Our Case Number: ABP-317767-23
Planning Authority Reference Number:

**Re: Proposed construction of 39 residential units, widening of Pausdeen Bridge and all associated site works.
Newtown/Ardclough Road, Newtown, Celbridge, Co. Kildare.**

Planning Observation Submissions to An Bord Pleanála

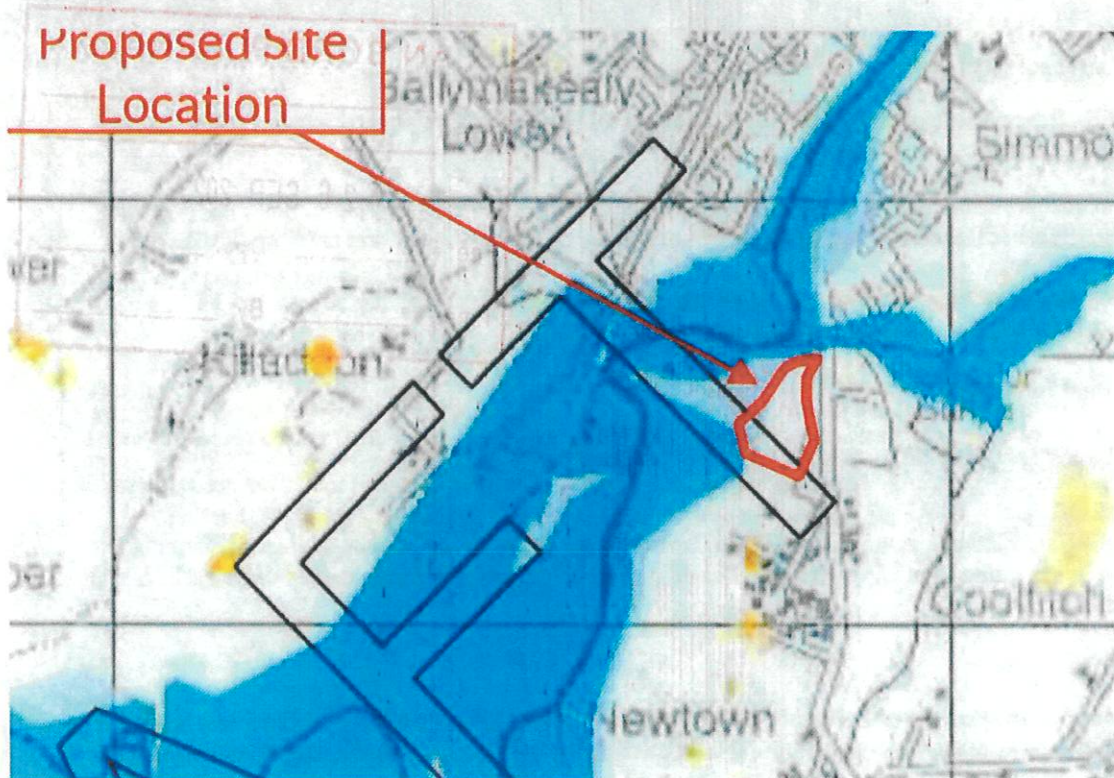
Very little tolerance: The predicted high water level of the site at 09LIFF02820 and 0.1% AEP is 52.95m. However evidence shows water further into the site. The Topographical survey indicates a Northwestern Fall

with levels varying from 53.80 to 53.0m OD at the Northwestern Edge. Are we to assume therefore that it was the illegal dumping which has helped to raise the site? Also 5cm clearance from a map without empirical current site data is hardly reassuring as good tolerance to flooding.

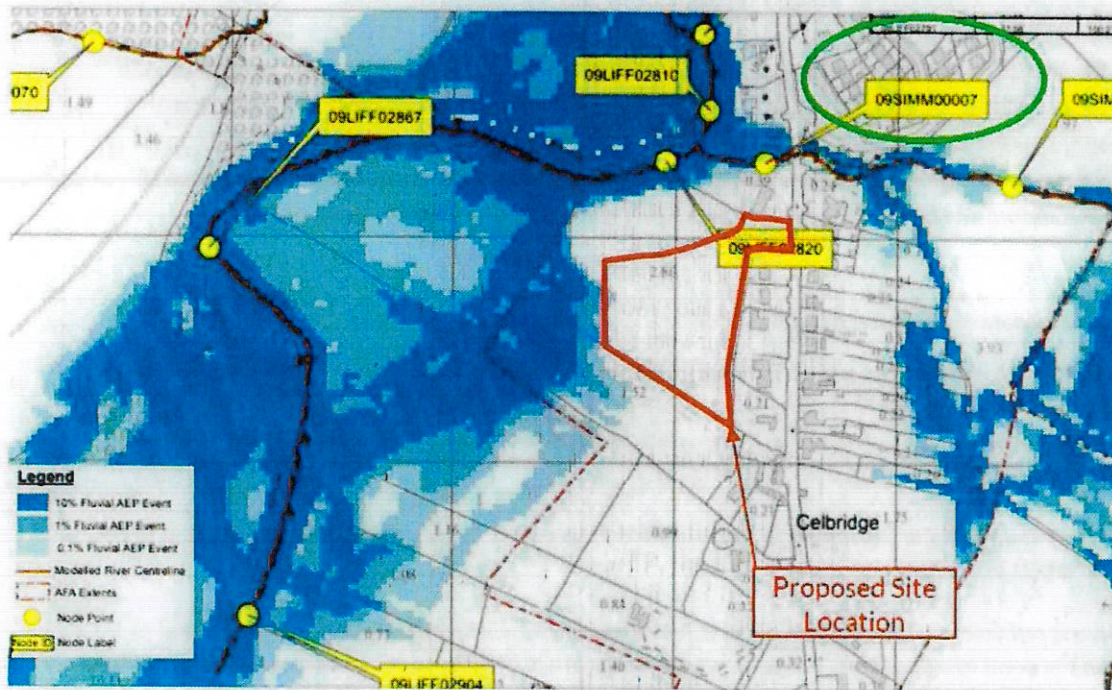
The below image was taken from the following document:

I have circled Chelmsford in green. The properties in the proposed site will not be able to obtain home insurance with flood cover included."

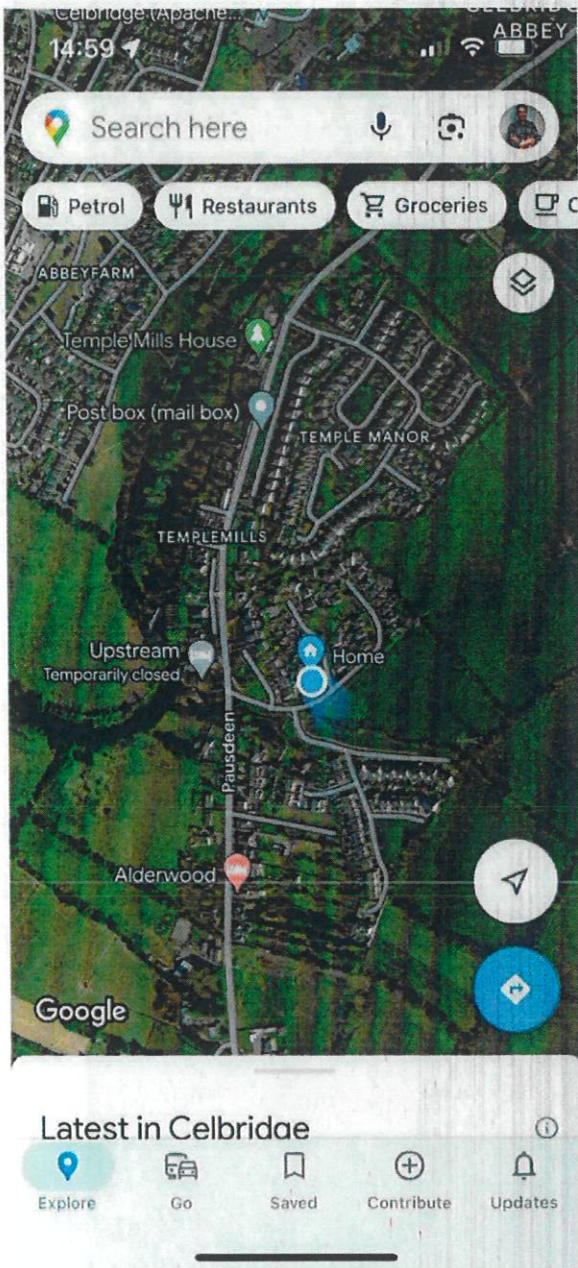
The diagram below shows that the site boundary (40m from river) would be the closest development to the flood plain on the west side of the Ardclough Road. No other development is as close to the Liffey flood zone on the southern side of the river.

Location: Drawing 210303-2-007 – Rev – VHA, Pedestrian Bridge

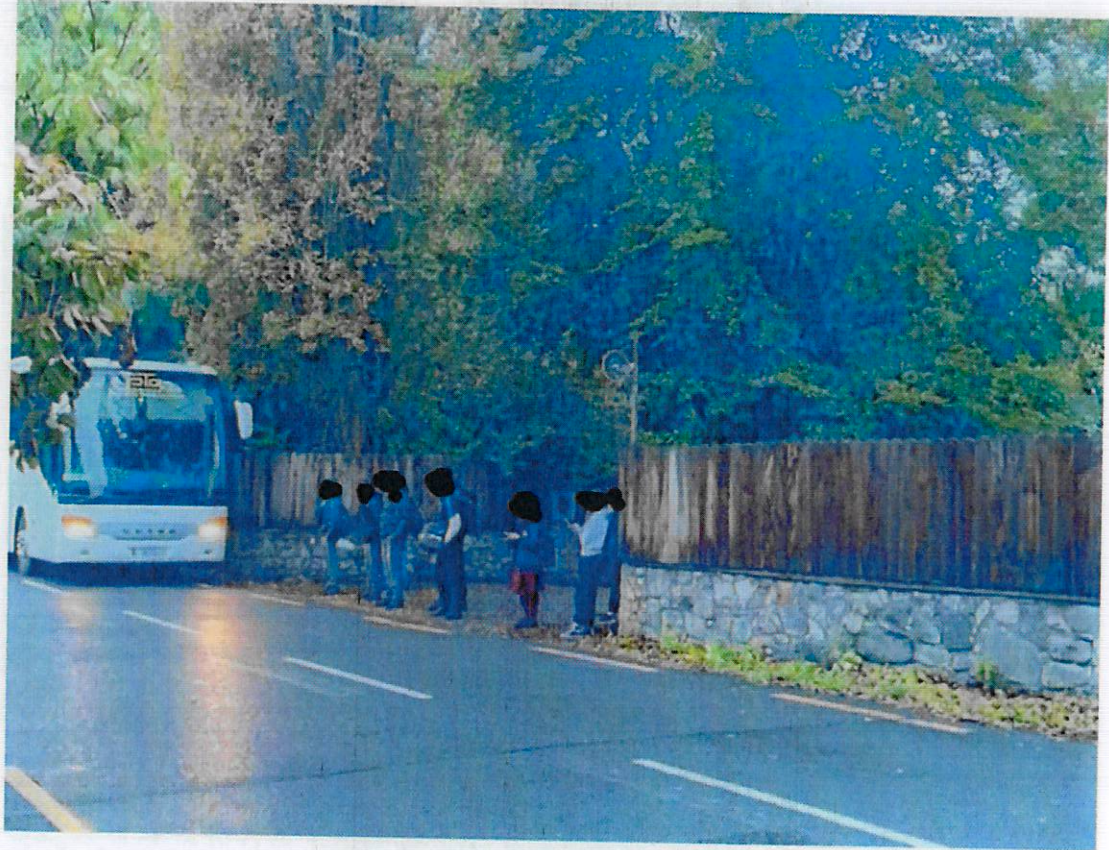
Section: 3.8 problem

Information in the Bruton Consulting Engineers Road Safety report is not true or correct. The entrance at Chelmsford is an extremely busy junction during peak times (Work / School Times etc.). The entrance is the only access to Chelmsford and Chelmsford Manor Housing Estates which has a total of 95 Residential houses. Each house has an average of two motor vehicles which in turn means 190 motor vehicles can pass through the entrance at any one time. There is no dedicated bus stop for the children of Chelmsford going to school. This applies to the new Council Estate in Newtown recently acquired and the proposed site. There are no bus stop facilities at Simmonstown and Templemanor for children going to school on the bus. Note that cycling is not an option as there are no cycling routes.

Location: Drawing 210303-2-007 – Rev – VHA, Pedestrian Bridge

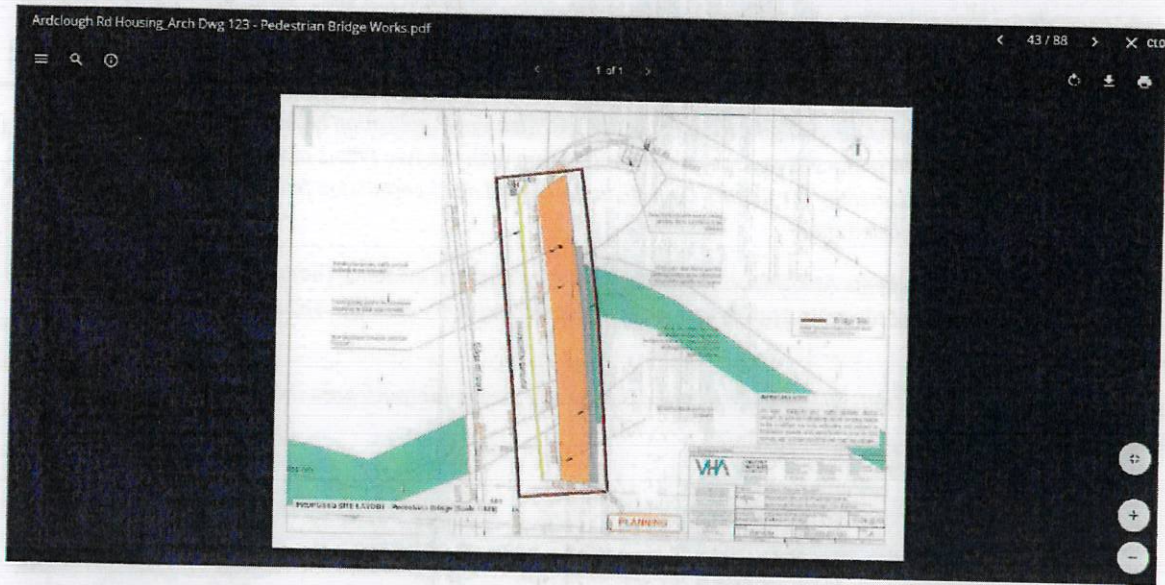
Section: 3.9 problem

The information in the Bruton Consulting Engineering Report or KCC Planning Application Report does not consider the ownership of the Common Green Areas at Entrance along with the two Pillars at the entrance to Chelmsford. The lands are not owned by the County Council, and they will need permission from the owner to carry out any works on this proposed site.

Resolution: The Chelmsford Residents Association should be given documented evidence that permission from the owner that any works on the planning application for bridge widening and new proposed zebra crossing has been given.
